ROCKWALL, TEXAS
 SH 205 & SH 552

RECORD DRAWINGS August 2011

LC NUMBER: 042-2854 CORPORATE DWG. NAME: SITE PLAN

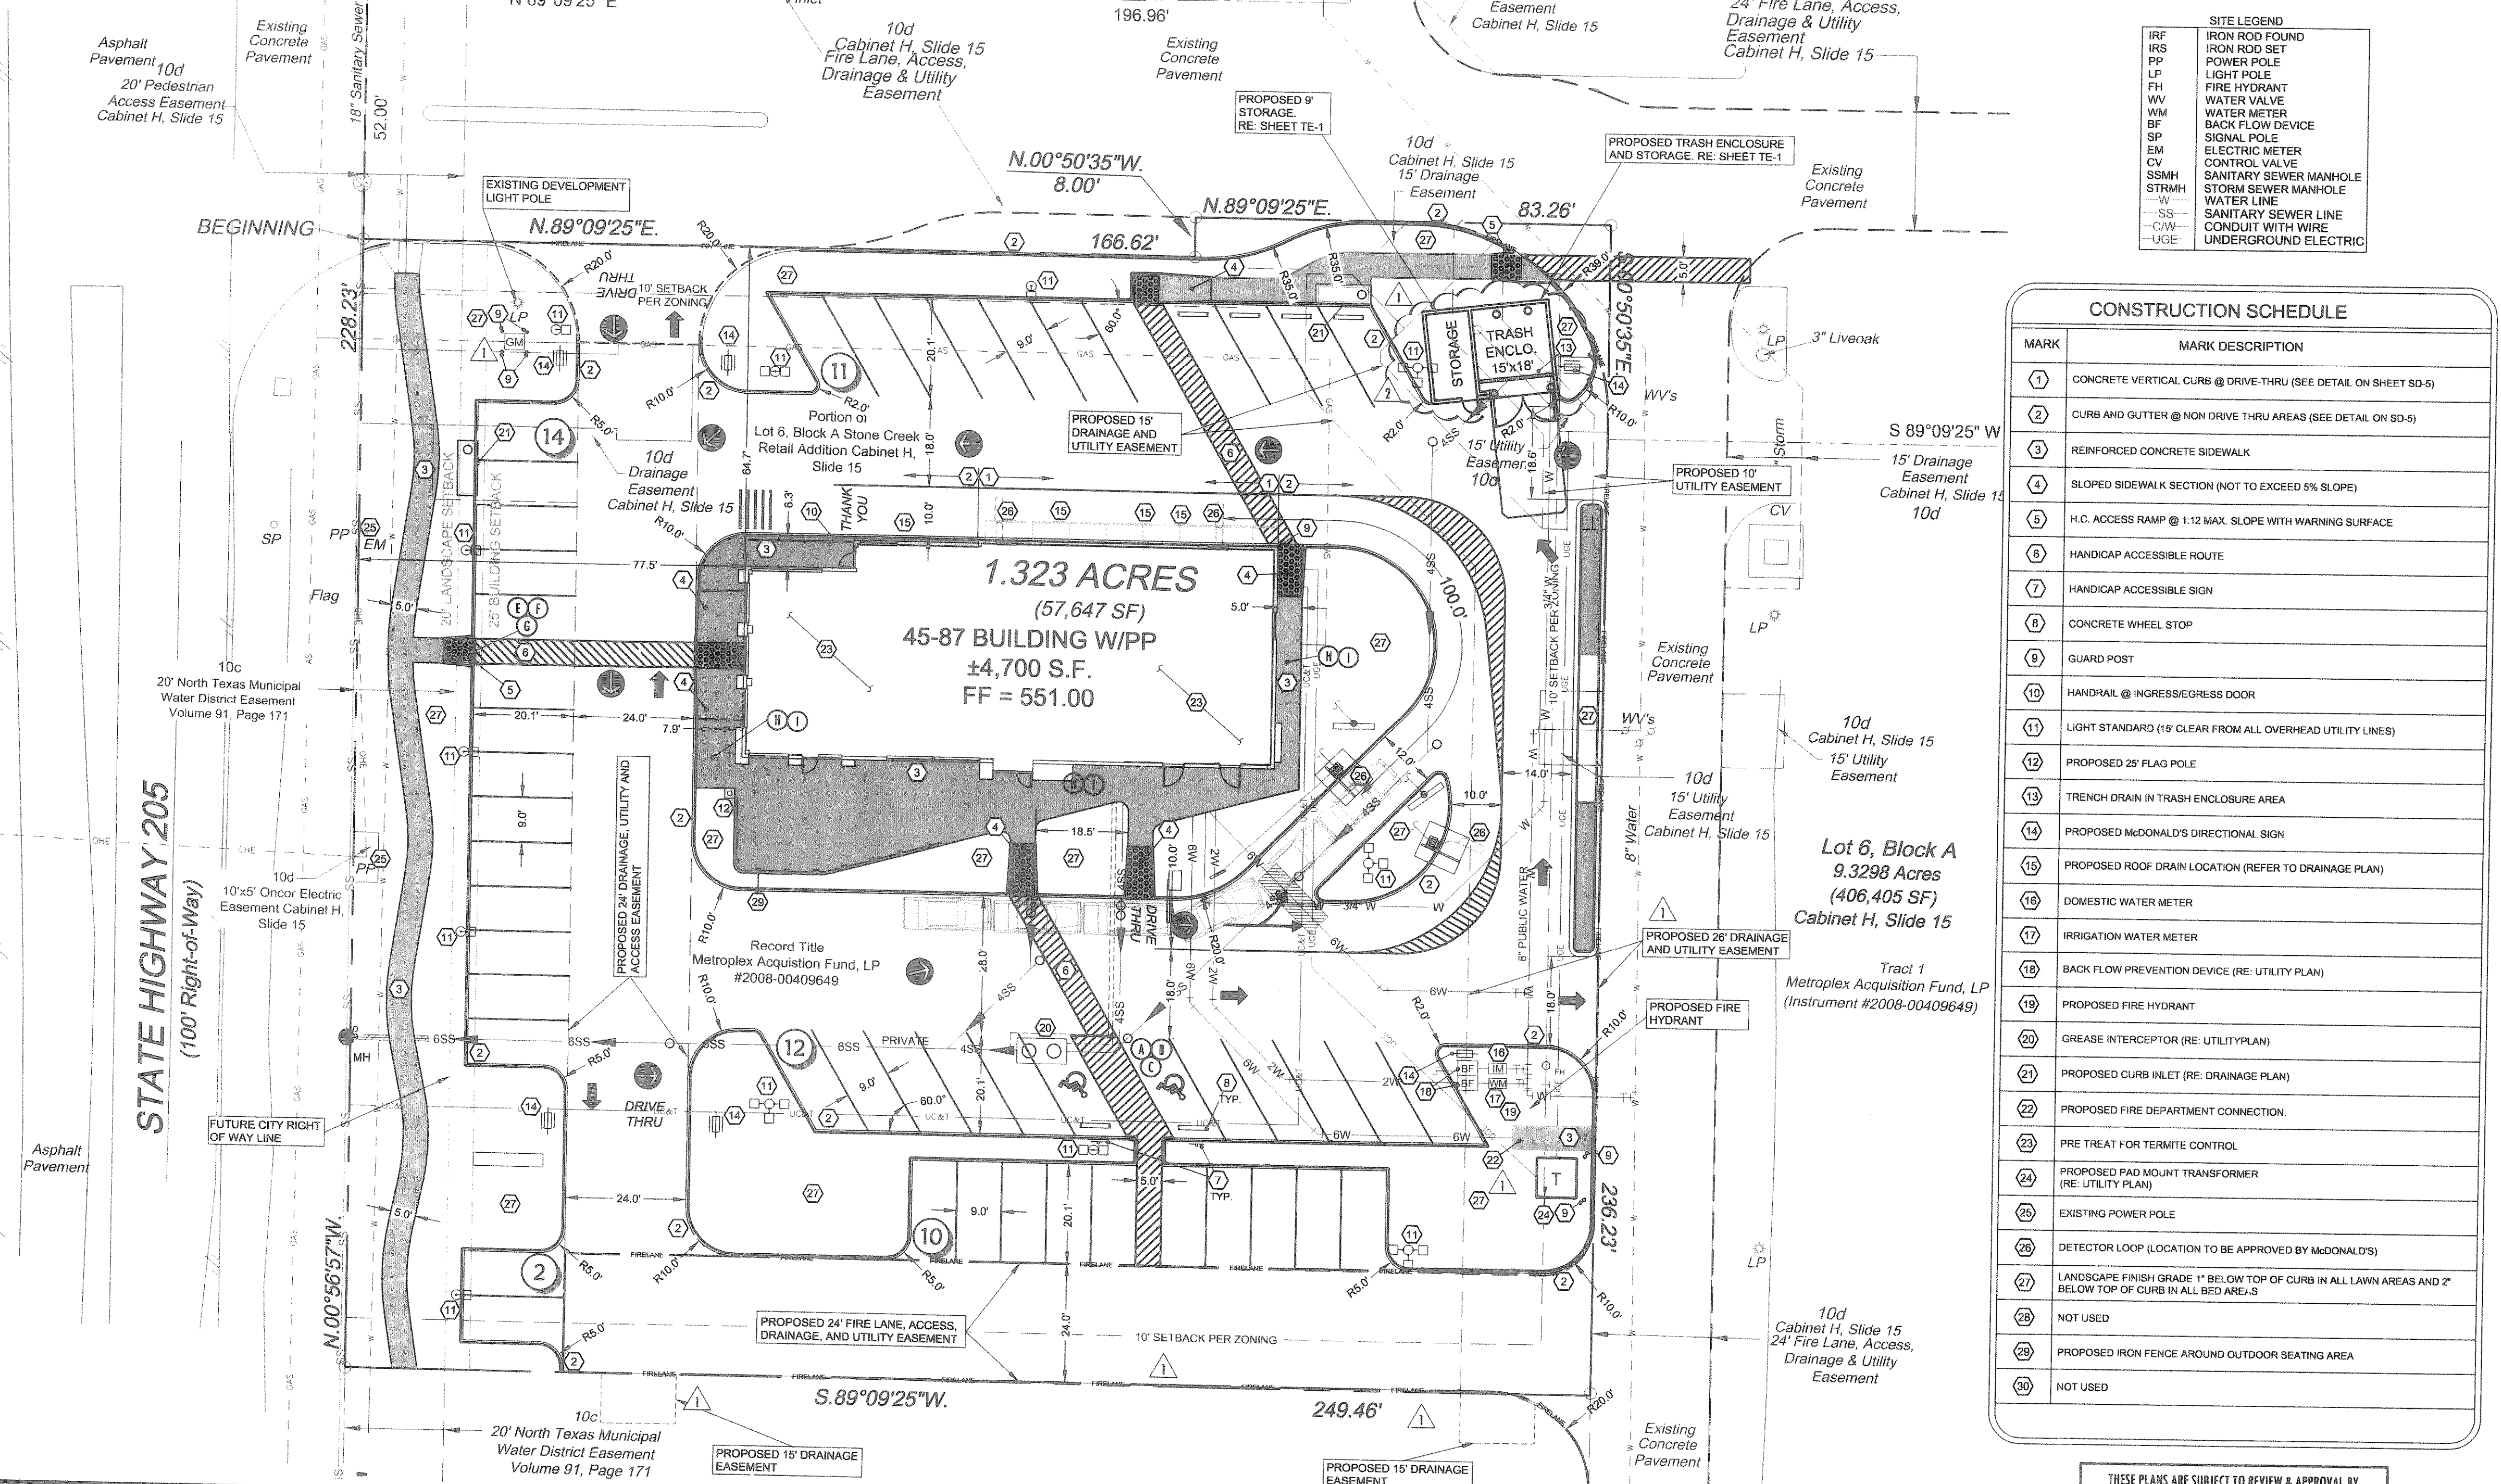
1. MOVED TRASH ENCLOSURE OUT OF DRAINAGE EASEMENT.
2. ADDED 15' WATER EASEMENT AT EAST SIDE OF PROPERTY.
3. MOVED ELECTRIC TRANSFORMER NORTH.
4. ADDED SINGAGE NOTE.
5. ADDED 2 OFF-SITE DRAINAGE EASEMENTS AT SOUTH PROPERTY LINE.
6. ADDED FIRE LANE AT THE SOUTH SIDE OF BUILDING.
7. ADDED GUARD POST AROUND GAS METER.

1. MOVED TRASH ENCLOSURE EAST 1.5 FEET AND MADE STORAGE WIDER BY 1.5 FEET.
